Release Notification and Corrective Action

Name of Company: XTO Energy BOPCO # 260737	Contact: Kyle Littrell
Address: 522 W. Mermod, Suite 404 Carlsbad, N.M. 88220	Telephone No. 432-221-7331
Facility Name: PLU Big Sinks 3-25-31 Battery (API for PLU CVX JV BS #027H)	Facility Type: Exploration and Production

**Re: Remediation Work Plan
PLU Big Sinks 3-25-31 Battery
Incident Number nAB1731042349
Eddy County, New Mexico**

Site Receptor Map

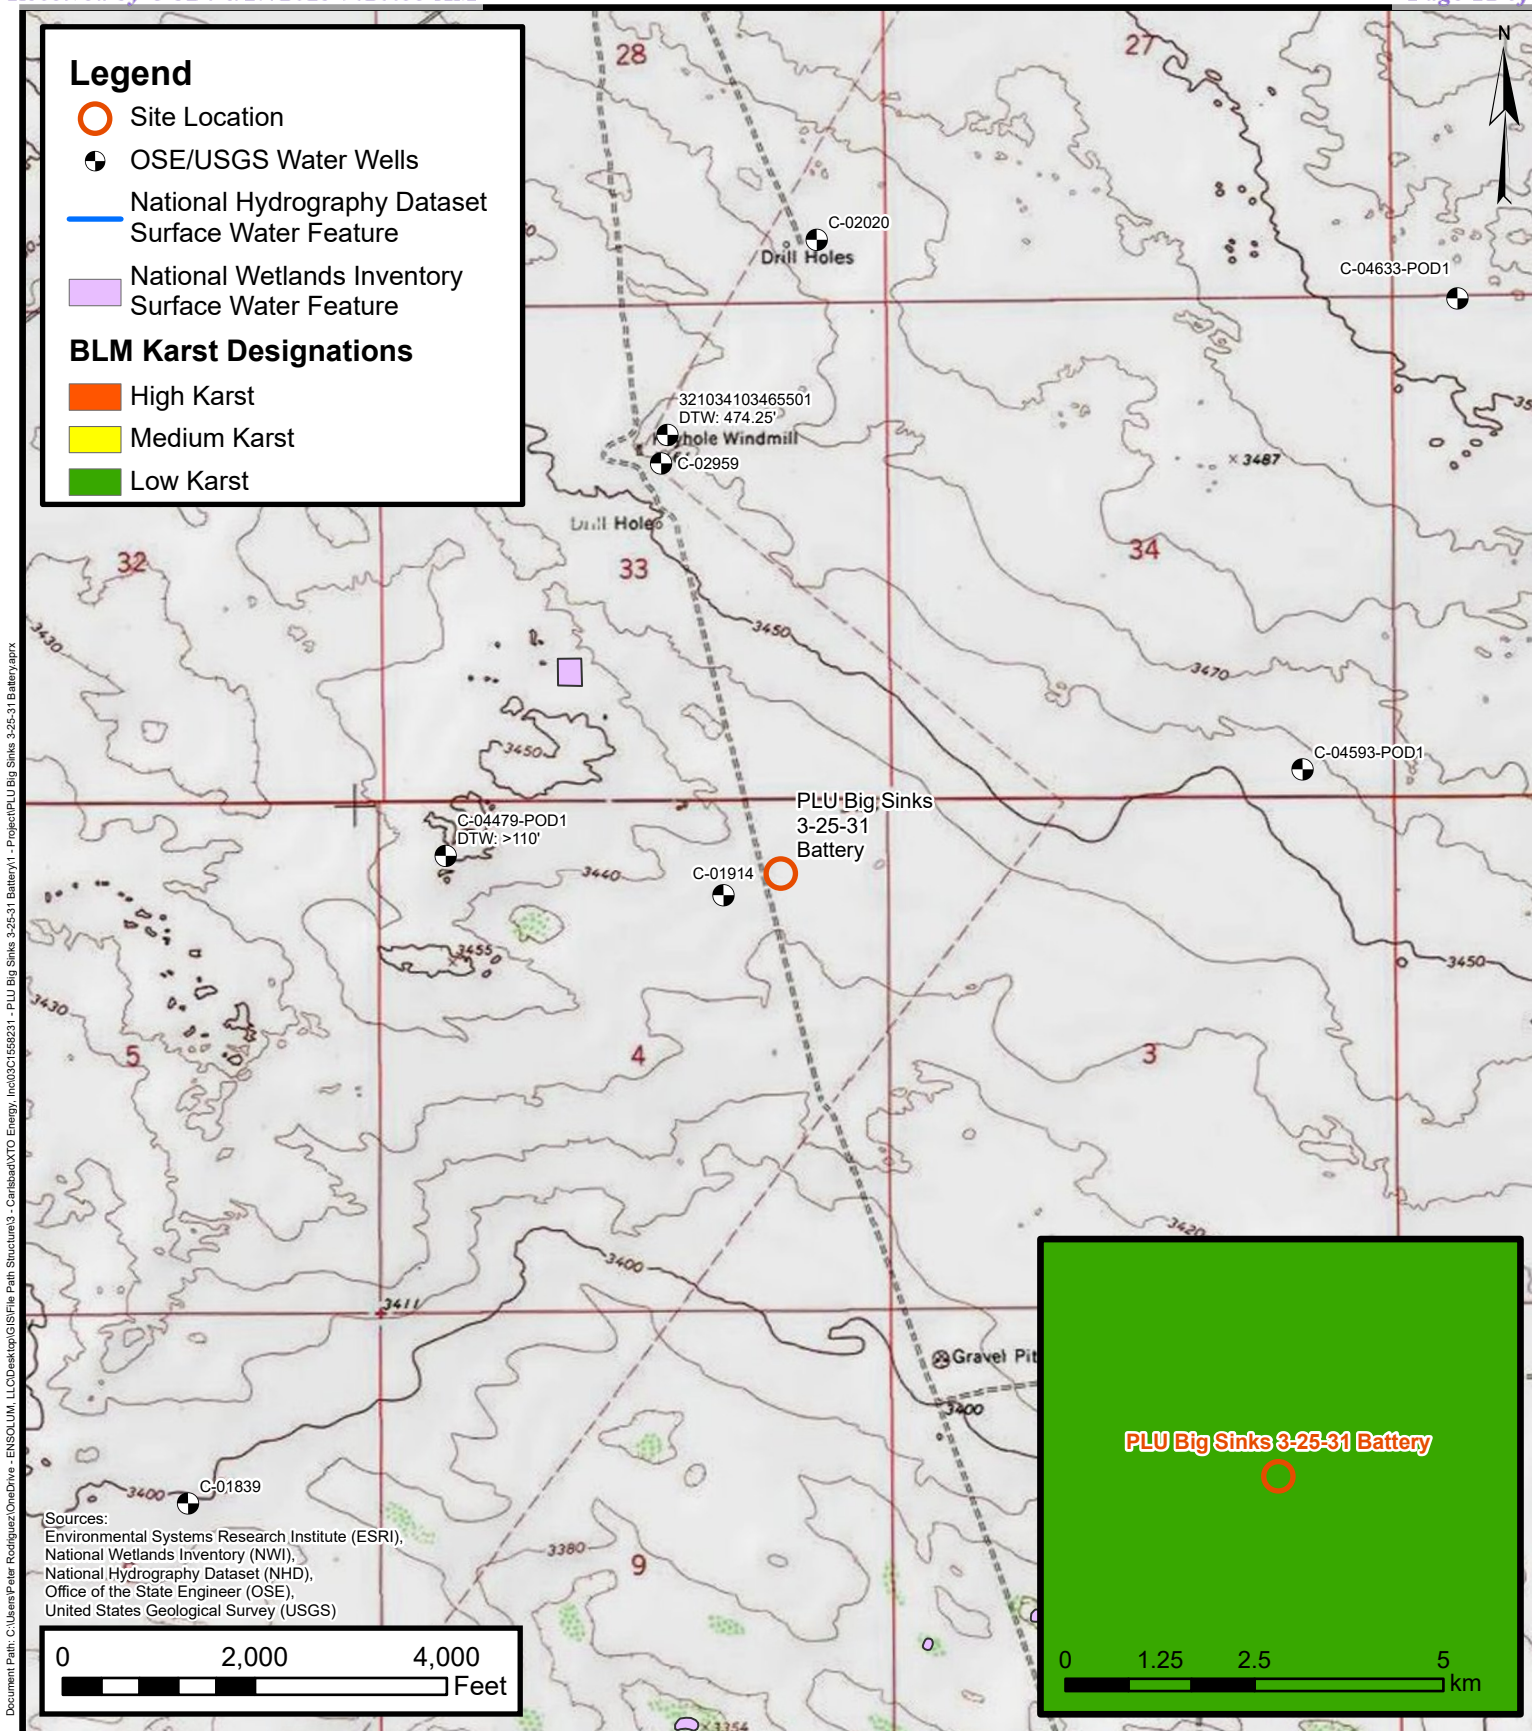
The Site was characterized to assess the applicability of Table I, Closure Criteria for Soils Impacted by a Release, of Title 19, Chapter 15, Part 29 (19.15.29) of the New Mexico Administrative Code (NMAC). Results from the characterization desktop review are presented on page 3 of the Form C-141, Site Assessment/Characterization. Potential Site receptors are identified on Figure 1.

Depth to groundwater at the Site is estimated to be greater than 100 feet below ground surface (bgs) based on the nearest groundwater well data. The closest permitted groundwater well with depth to groundwater data is New Mexico Office of the State Engineer (NMOSE) well C-04479, located 0.65 miles west of the Site. The groundwater well was drilled during October 2020 to a total depth of 110 feet bgs. No groundwater was encountered, and the well was plugged following NMOSE procedures. The well records are included in Appendix A. All wells used for depth to groundwater determination are presented on Figure 1.

The closest continuously flowing or significant watercourse to the Site is an emergent wetland, located approximately 8,131 feet southeast of the Site. The Site is greater than 200 feet from a lakebed, sinkhole, or playa lake and greater than 300 feet from an occupied residence, school, hospital, institution, church, or wetland. The Site is greater than 1,000 feet from a spring and is not within a 100-year floodplain or overlying a subsurface mine. The Site is not underlain by unstable geology (low potential karst designation area). Site receptors are identified on Figure 1.
